Subject: **Comments to Proposed Rule and Part 61 Guidance, Low-Level Radioactive Waste Disposal, 80 FR 16082 and 80 FR 15930**

CD15-0163

COMMENTS ON THE PROPOSED REVISIONS TO 10 CFR PART 61

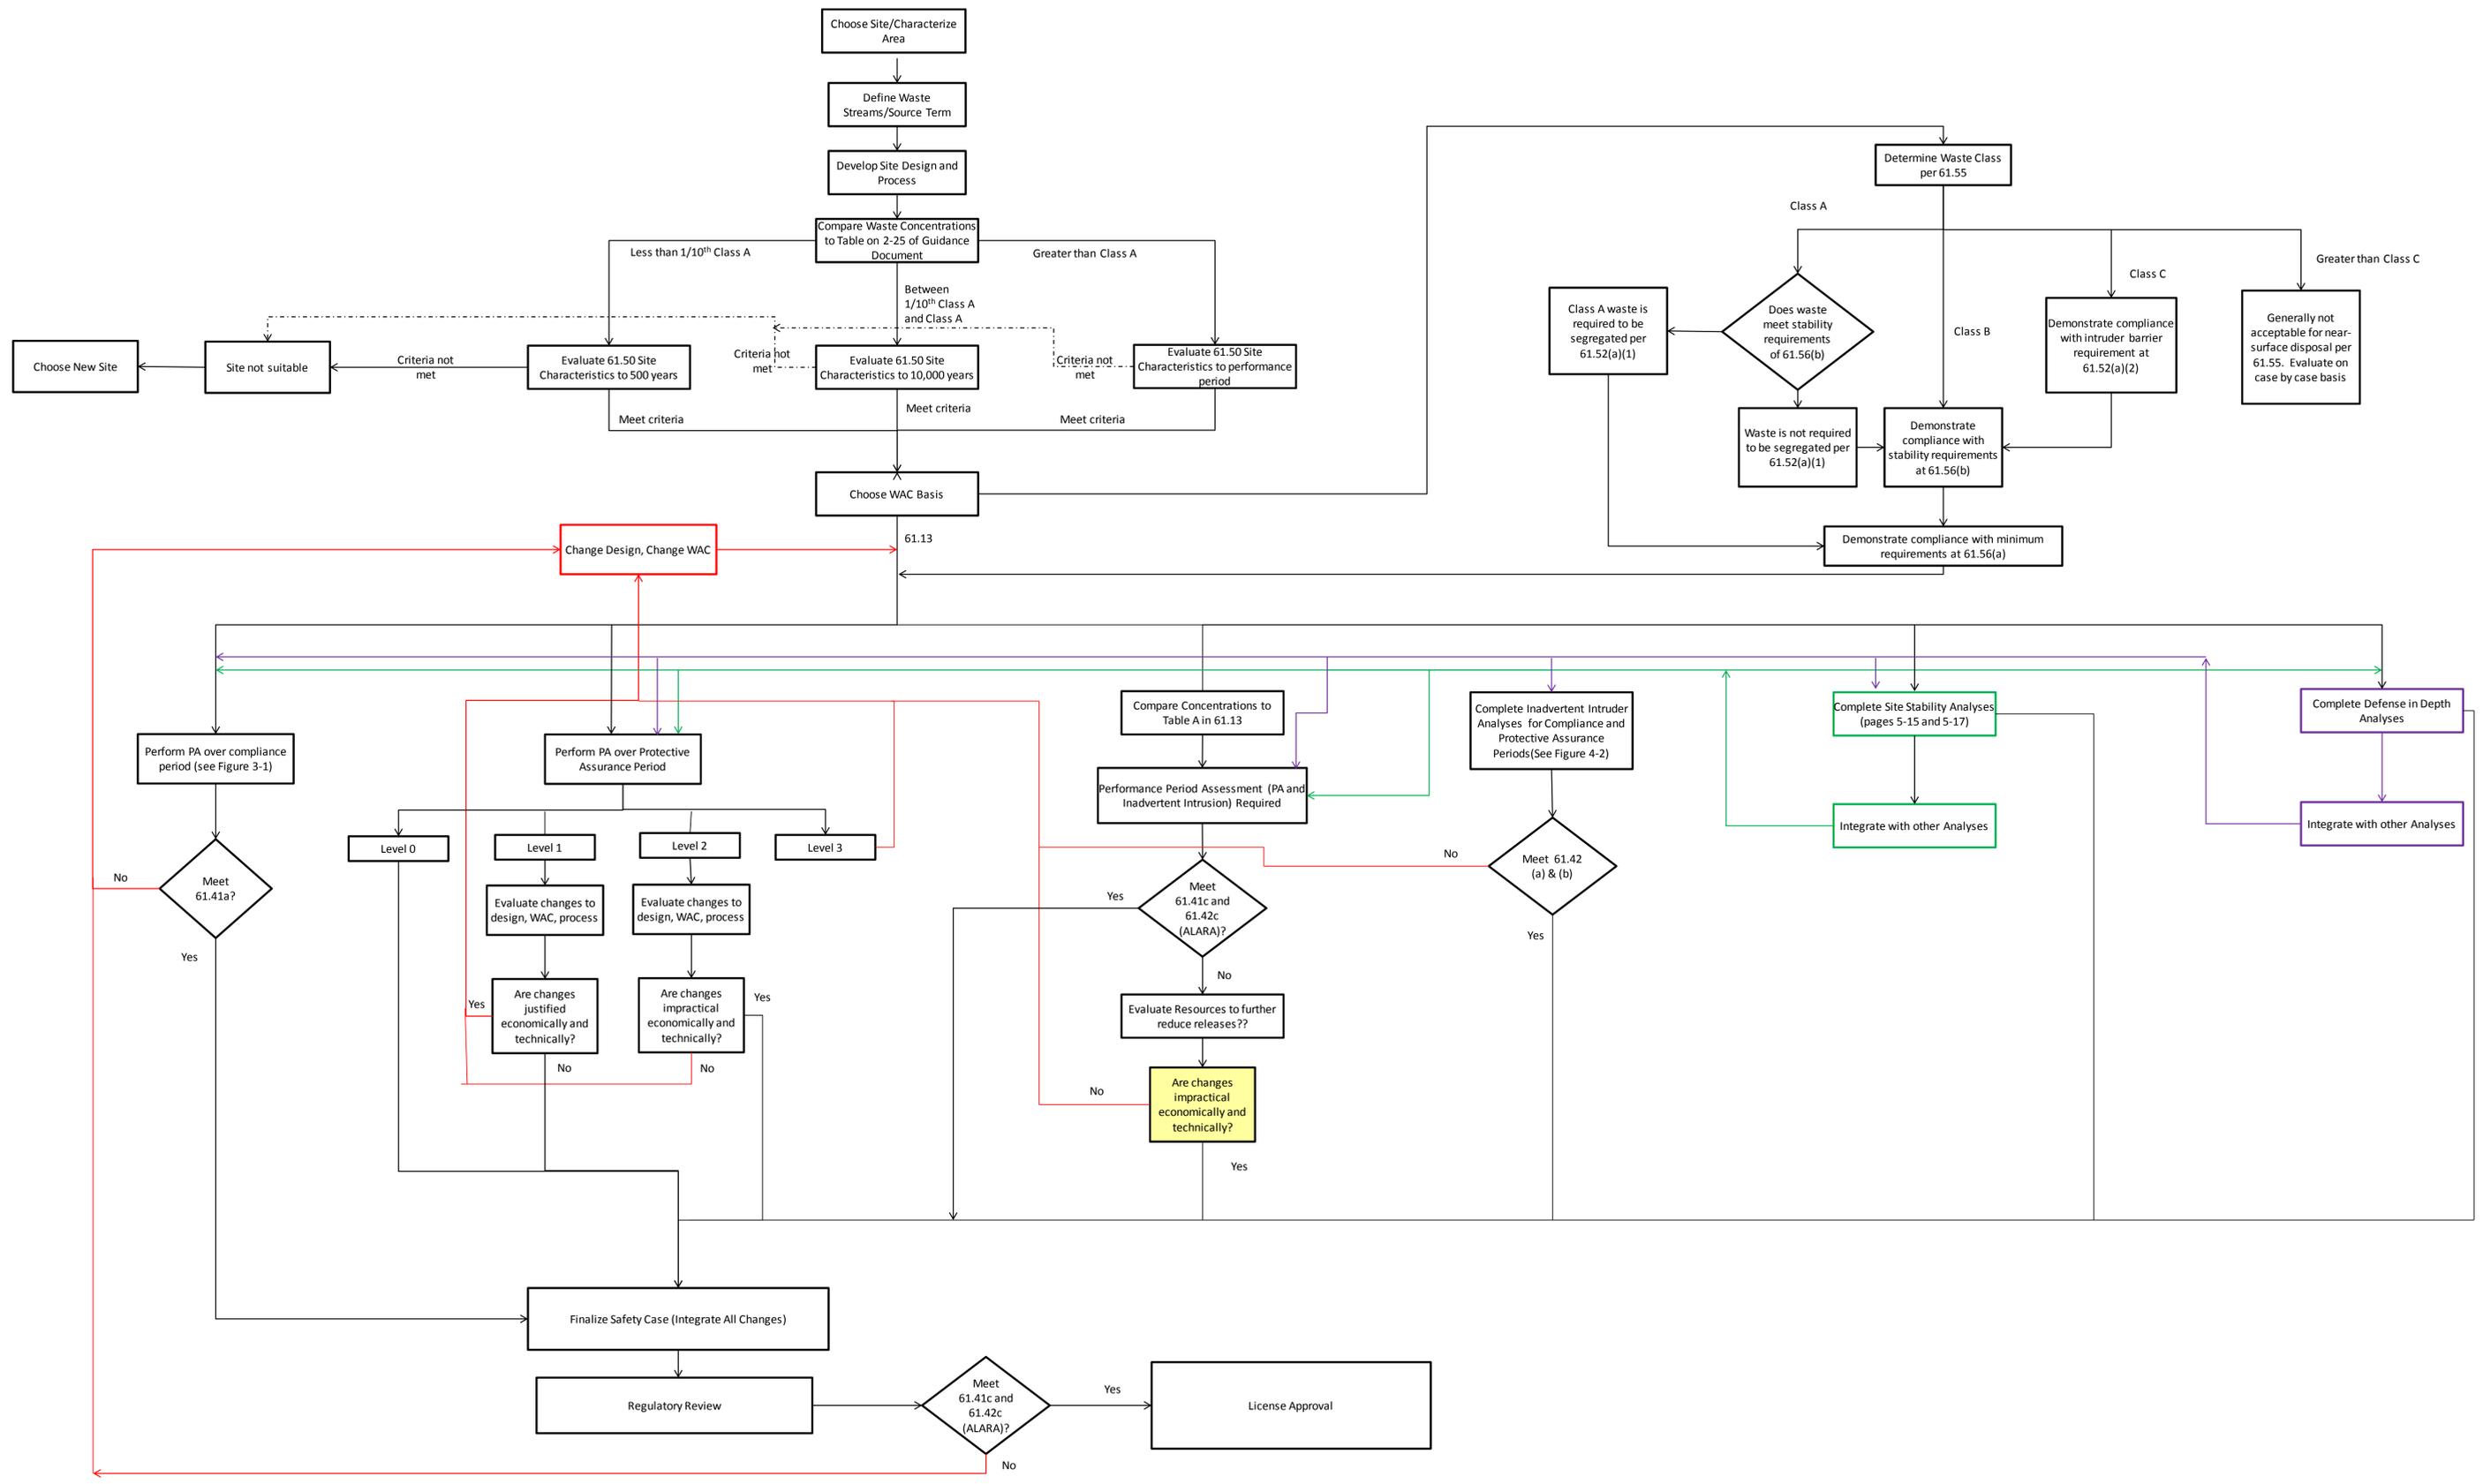
We attempted to create a flowchart to fit the pieces of the proposed rule together (see Figure 1). This flowchart clearly illustrates the cumbersome nature of the process. We recommend several changes that should streamline the process, including using a two-tier system. These are discussed in further detail in the following sections.

Recommendation – We propose that the NRC include a flowchart of the process so that an applicant or licensee can understand the components, requirements, key decision points, and how they fit together.
